Serial No. 09/673,787 Filed: October 20, 2000

REMARKS

Fig. 2

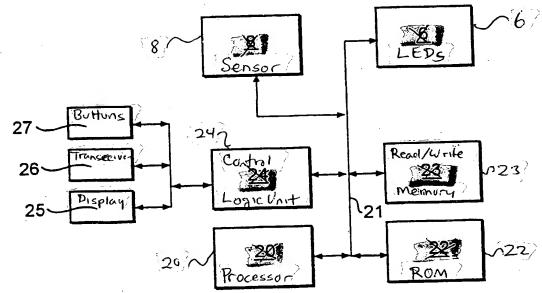
Section 4 of the Office Action objected to Fig. 2 under 37 C.F.R. §1.84(n) and (o) because Fig. 2 fails to include descriptive labels for boxes numbered 6, 8, 20 and 22-27.

Applicant hereinabove has amended Fig. 2 to add descriptive labels to the boxes numbered 6, 8, 20, and 22-27 as follows:

6 -> "LEDs" 23 -> "Read/Write Memory" 8 -> "Sensor" 24 -> "Control Logic Unit" 20 -> "Processor" 25 -> "Display" 22-> "ROM" 26 -> "Transceiver"

22-> "ROM" 26 -> "Transceive 27 -> "Buttons"

In view of the remarks above, the amendments to Fig. 2 and the Replacement Sheet in Exhibit B, applicant respectfully requests that the objection to Fig. 2 be reconsidered and withdrawn.
